“AMENDMENT” OF THE PRELIMINARY DRAINAGE REPORT

Claremont Business Park 2 Filing No.1

A RESUBDIVISION OF TRACT C OF CLAREMONT BUSINESS PARK FILING NO. 2

JULY 2020

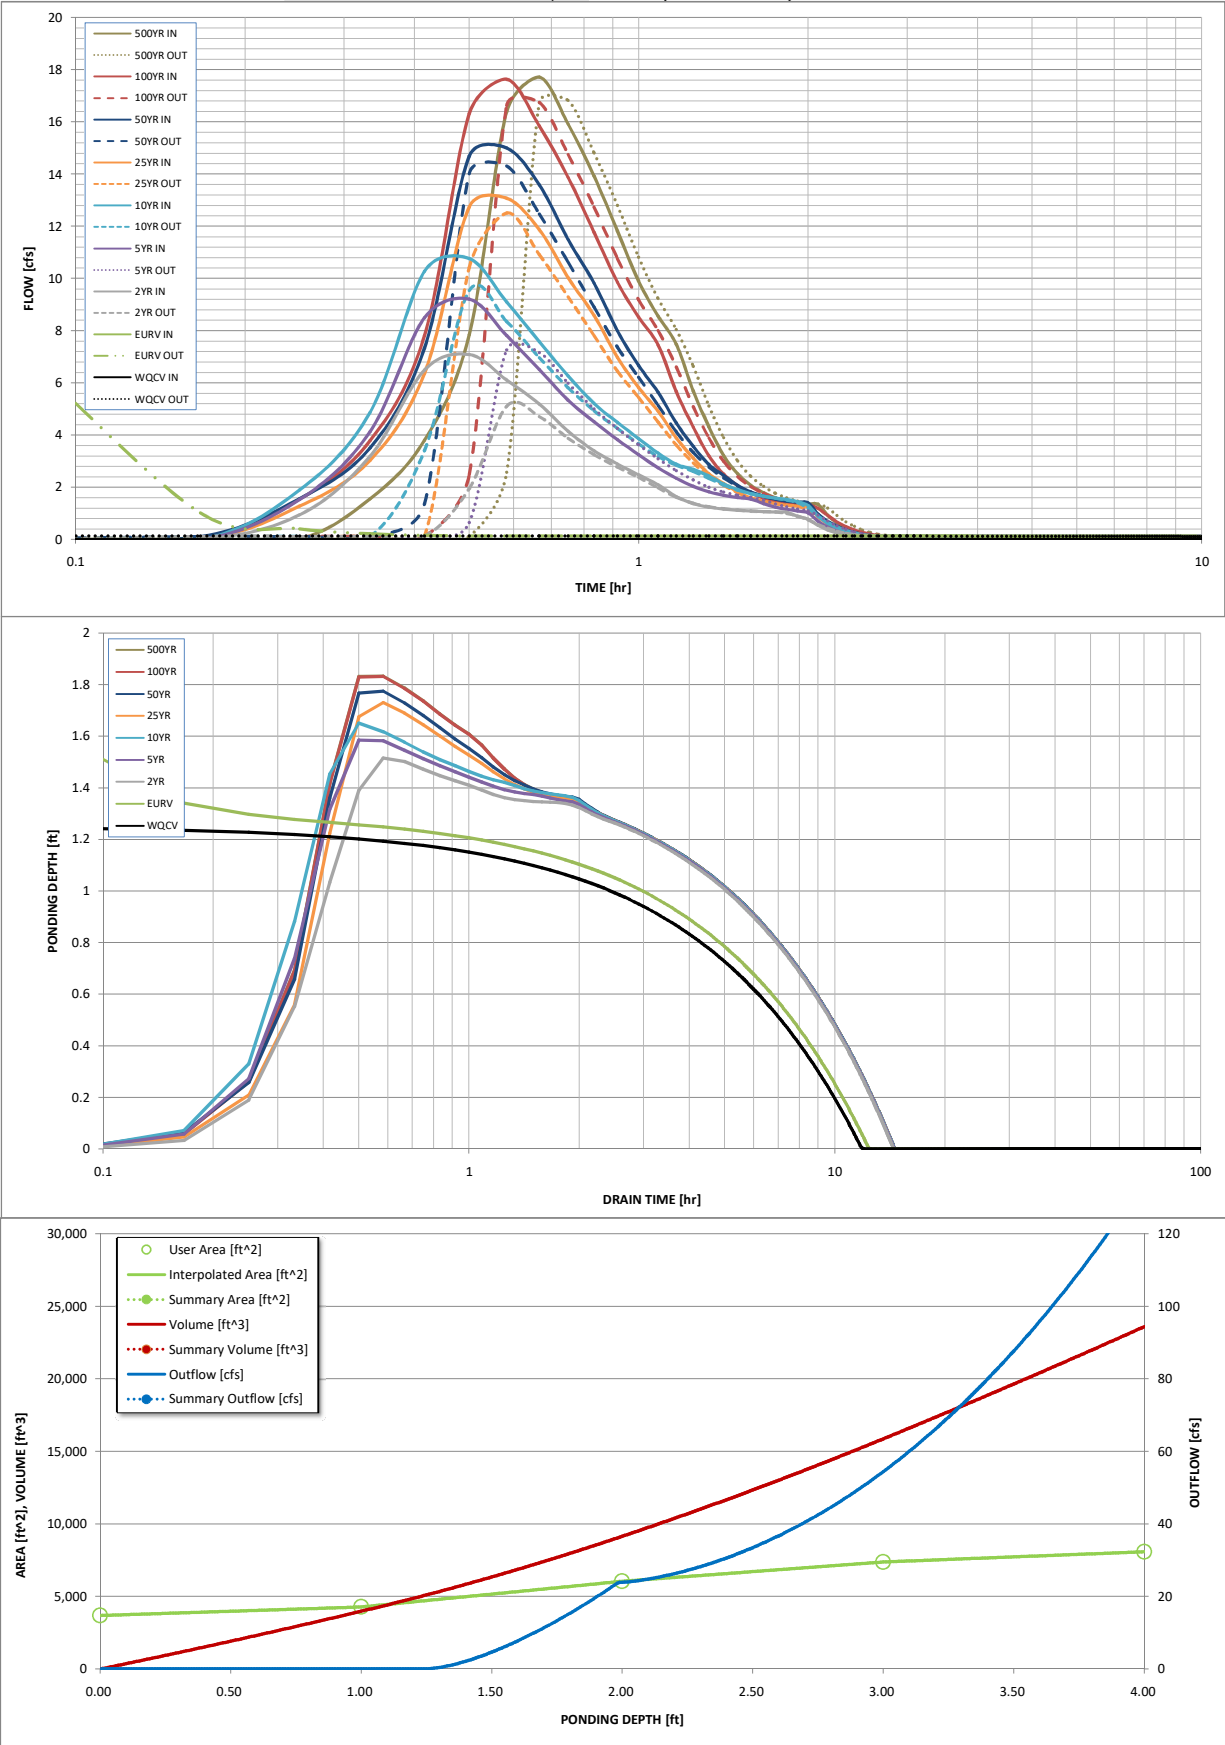
should be Claremont Business Park Filing No. 2

NOTE: Per resolution 15-426 of the BCC (included in Appendix), on-site WQCV is required but on-site stormwater detention is not required per the FDR for Claremont Commercial Subdivision Fil. 2.

COMMENT ADDRESSED

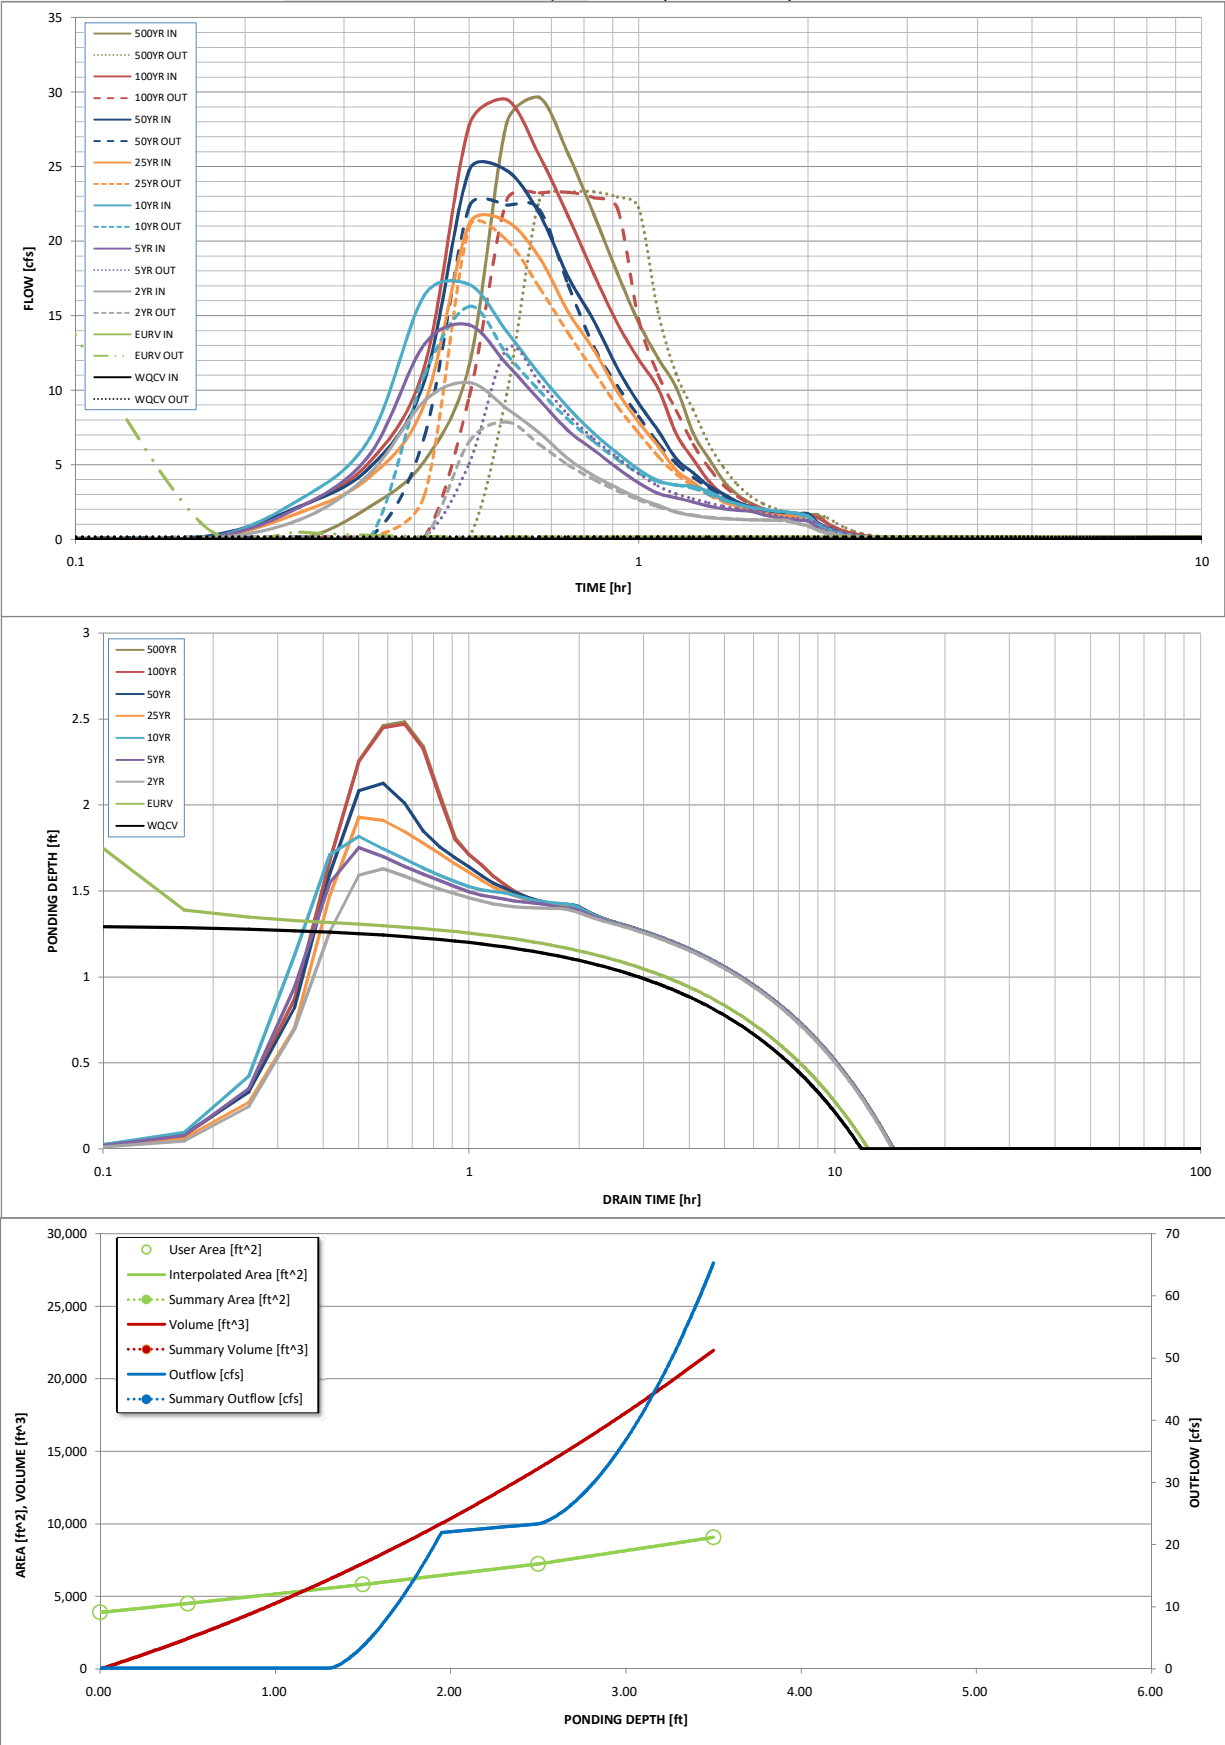
should be Claremont Business Park Filing No. 2

NOTE: Per resolution 16-426 of the BOCC (included in Appendix), on-site WQCV is required but on-site stormwater detention is not required per the FDR for Claremont Commercial Subdivision Fil. 2.

COMMENT ADDRESSED

COUNTY OF EL PASO, STATE OF COLORADO
PROPOSED DRAINAGE MAP

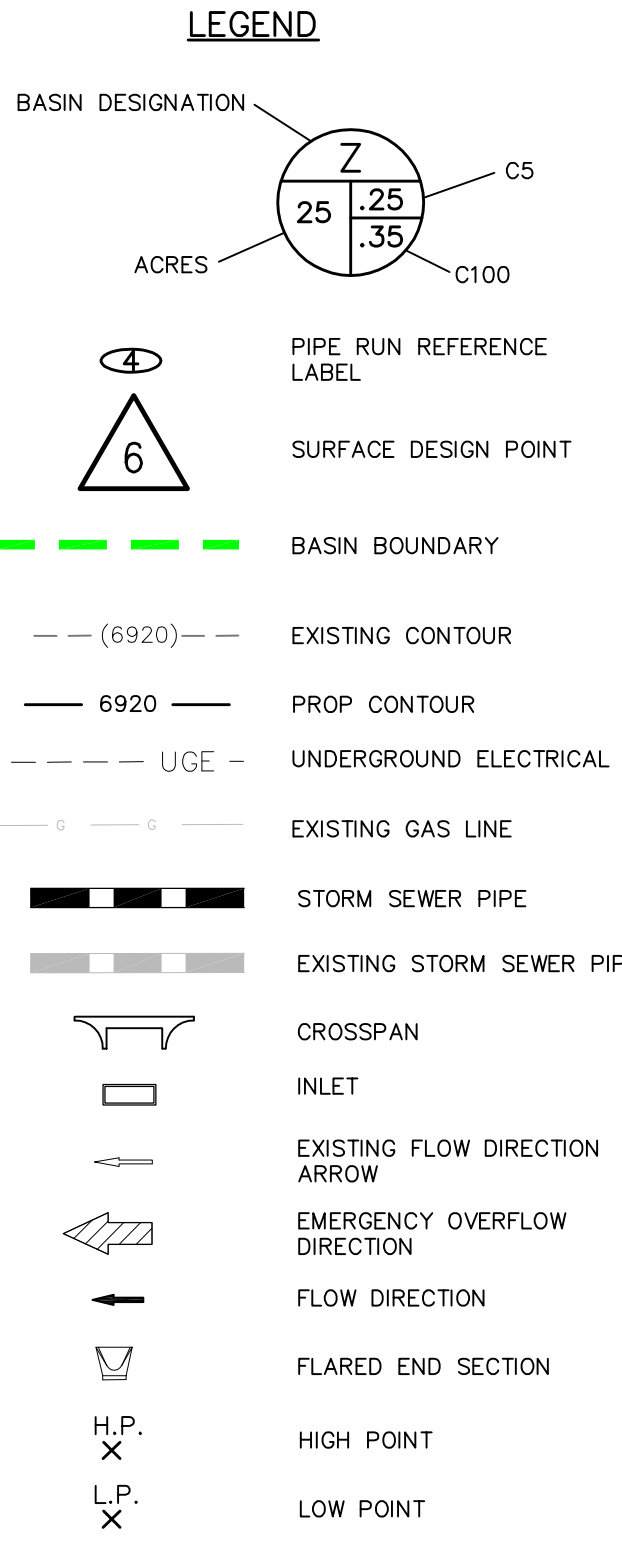
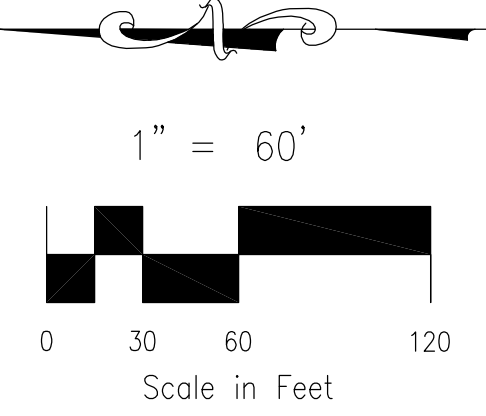
It appears that the existing 30" stub may conflict with your proposed 30" ADS pipe. Please clarify.

COMMENT ADDRESSED
Will this 30" stub be removed. It appears that it may conflict with
